RE: **Palen Solar Power Project, Docket No. 09-AFC-7**
Responses to January 14, 2010 CEC Workshop Queries (Groundwater)
Technical Areas: Soil & Water Resources

**Responses to CEC Workshop,
January 14, 2010
Soil and Water Resources
(Groundwater)**

**Palen Solar Power Project
Docket No. 09-AFC-7**

Groundwater Data Responses to January 14, 2010 CEC Workshop Queries – Palen Solar Power Project

Palen Solar Power Project
Figure DR-S&W-194-1 (Rev. 1)
Average Annual Precipitation
1931-1961 (Hely & Peck, (1964)
Chuckwalla Valley
Groundwater Basin

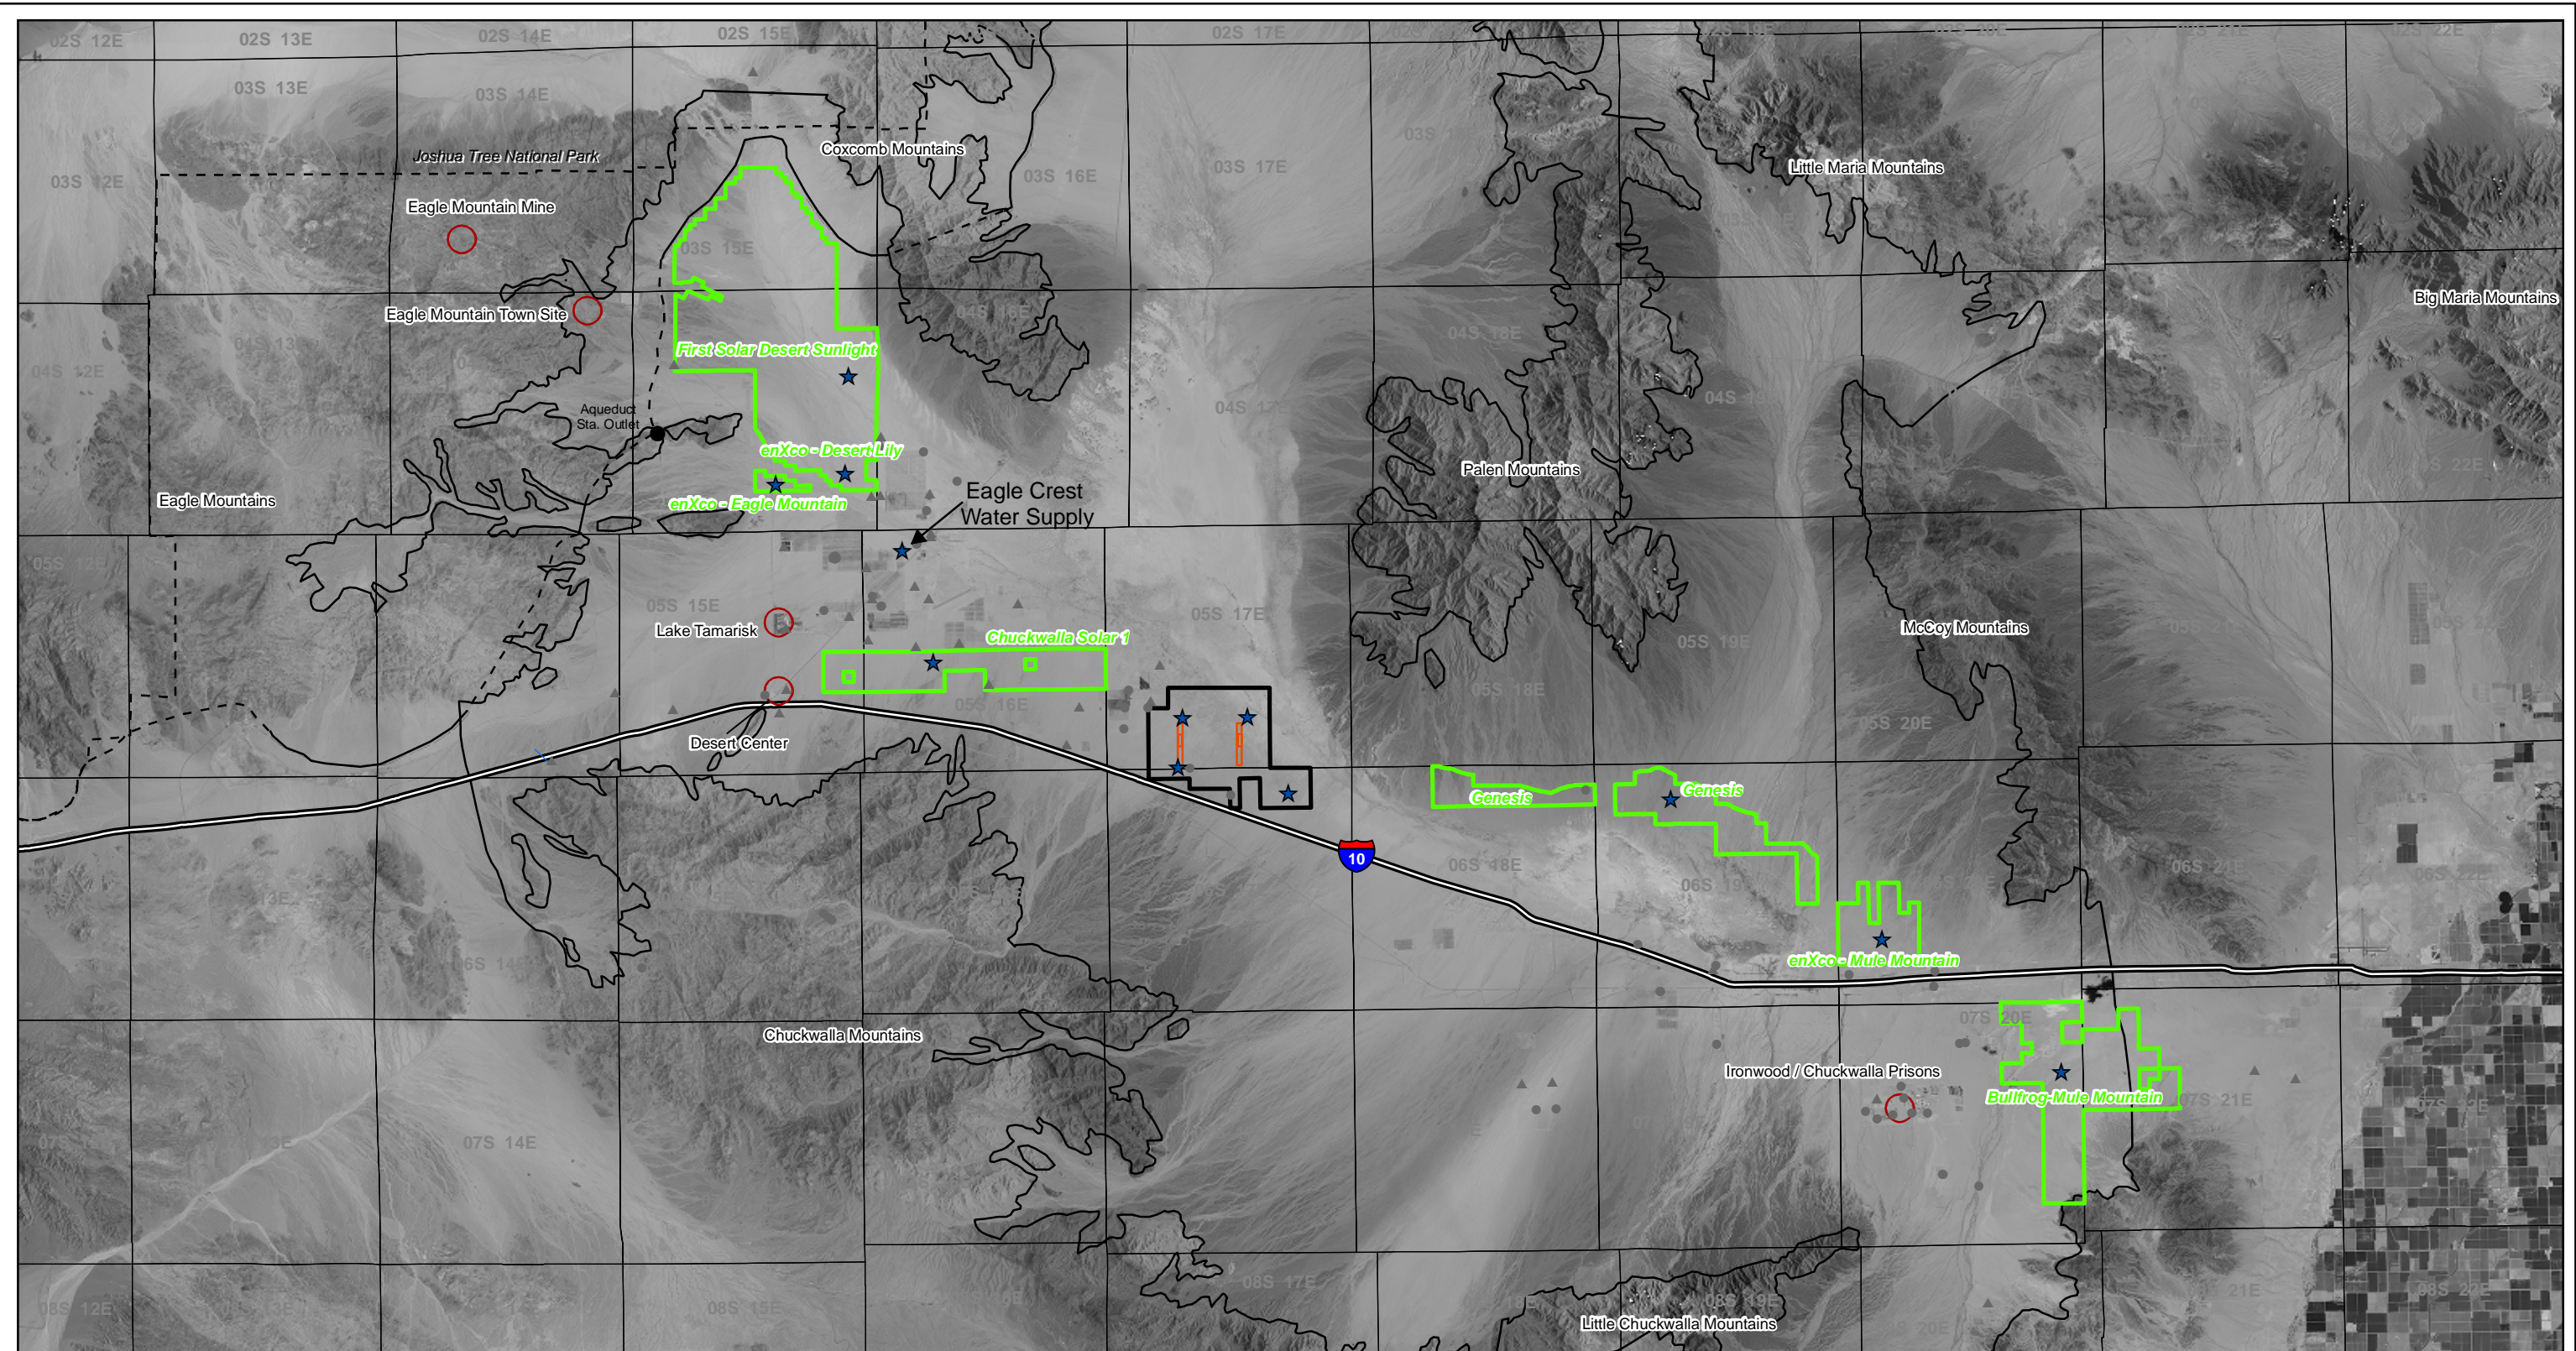
Update the runoff recharge estimates (DR-S&W-194) to reflect 2, 5, and 10% of total calculated runoff value. Use the Basin inflow/outflow example from Genesis (WorleyParsons 2009b).

In revising the infiltration estimate, the first step was to overlay the average annual isoheytal contours shown on Figure 6 from Hely and Peck (1964) onto the topography of the Chuckwalla Valley Groundwater Basin (Basin) (Figure DR-S&W-194-1 [rev1]). The second step was to multiply the

average annual precipitation within each contour times the area of the contour to derive an estimate of total precipitation in acre-feet for the Basin. Lastly, the total within each contour is multiplied by percentages of 3%, 5% and 10% representing an estimate of infiltration from precipitation within the contour and summing the individual areas to a total annual infiltration volume (acre-feet) for the Basin. Table DR S&W-194-1 (rev1) presents the estimate of total annual infiltration for the Chuckwalla Valley Groundwater Basin for these estimates of infiltration which vary from about 8,600 acre-feet (3%) to 28,600 acre-feet (10%). The infiltration estimate of 3% of precipitation compares favorably to the value estimated by WorleyParsons (2009a, Table DR-151-2) of 9,440 acre-feet.

Palen Solar Power Project
Figure DR-S&W-207b (rev1)
Project Only
Operational Supply
End of 30 Years

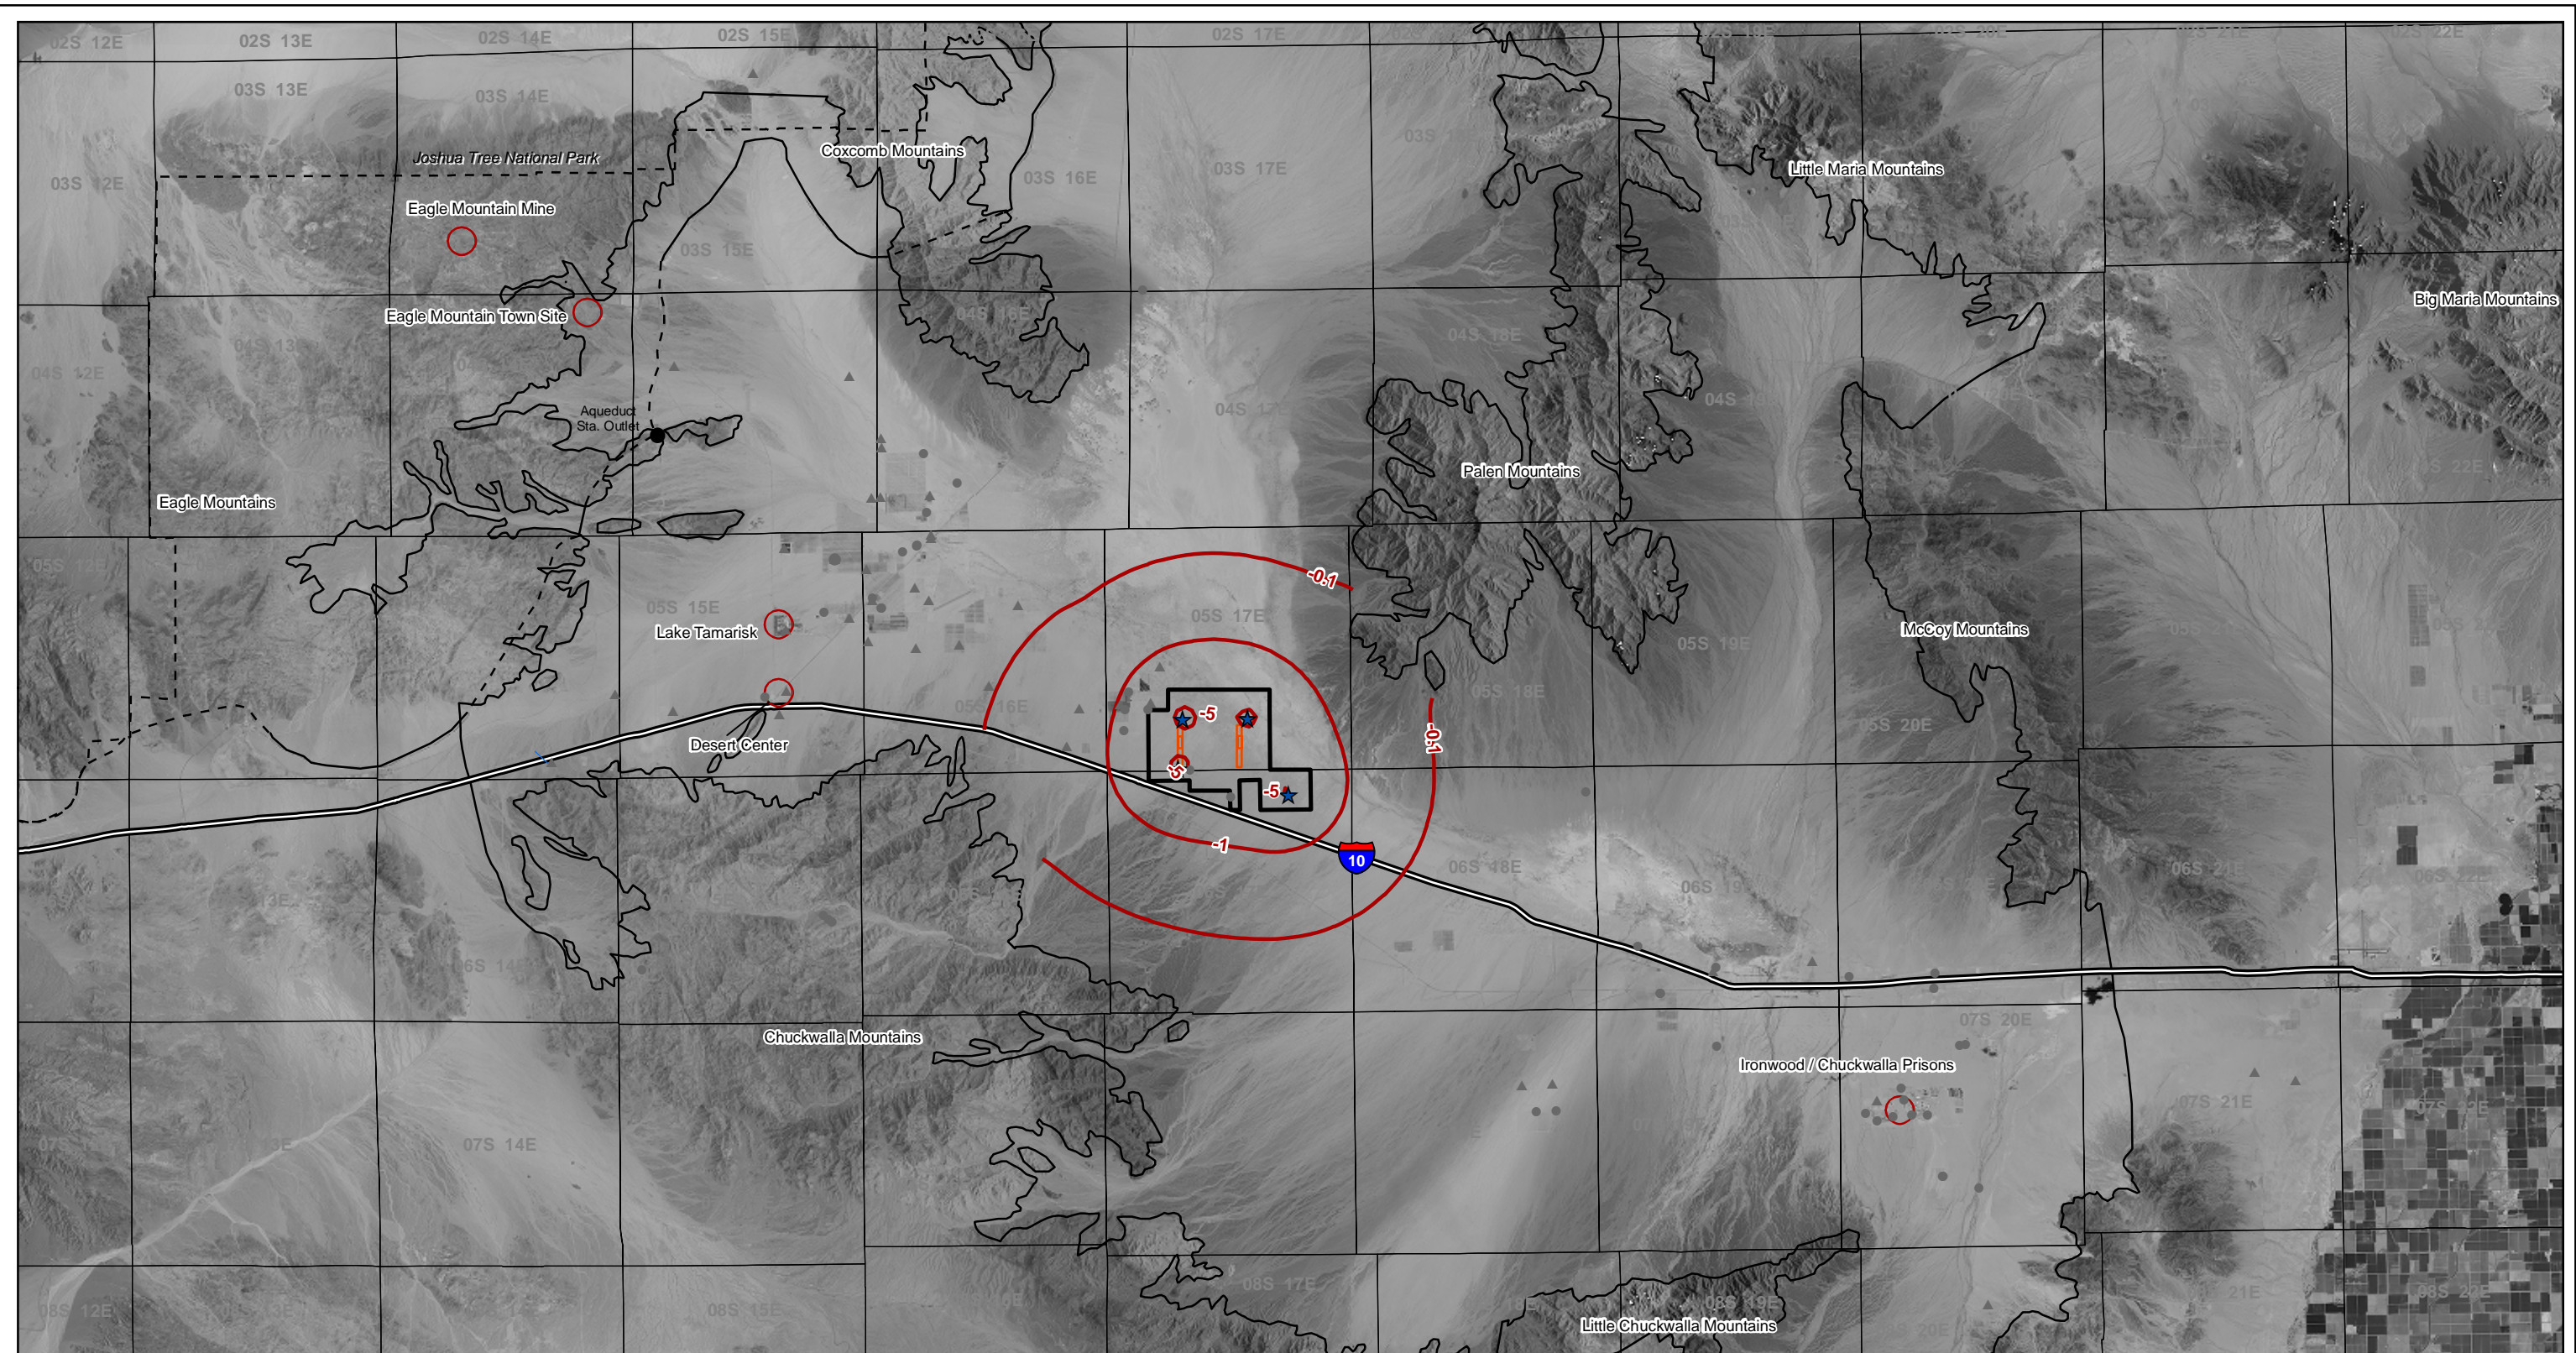
Provide evidence that Project water demand can be met without impact to nearby wells or creating Basin overdraft.

The “Project Only” simulation presents the predictive results from the stress applied to the model from the proposed project pumping as shown on the schedule provided in Table DR-S&W-207-1(rev1). The radius of influence for the “Project Only” simulation shows that after construction period and proposed water use of about 480 afy over three years the drawdown to the one-foot contour remains within the PSPP (Figure DR-S&W-207a[rev1]). At the end of operation the one-foot contour extends outward to encompass the area of CocoPah Farms, but the five-foot contour remains within the PSPP (Figure DR-S&W-207b[rev1]). The one-foot contour does not encroach into the northern portion of Palen Dry Lake and into the area where there are reportedly mesquite trees. These simulations show that the PSPP would not be expected to significantly impact offsite water supply wells using a significance threshold of a drawdown of five feet or more.
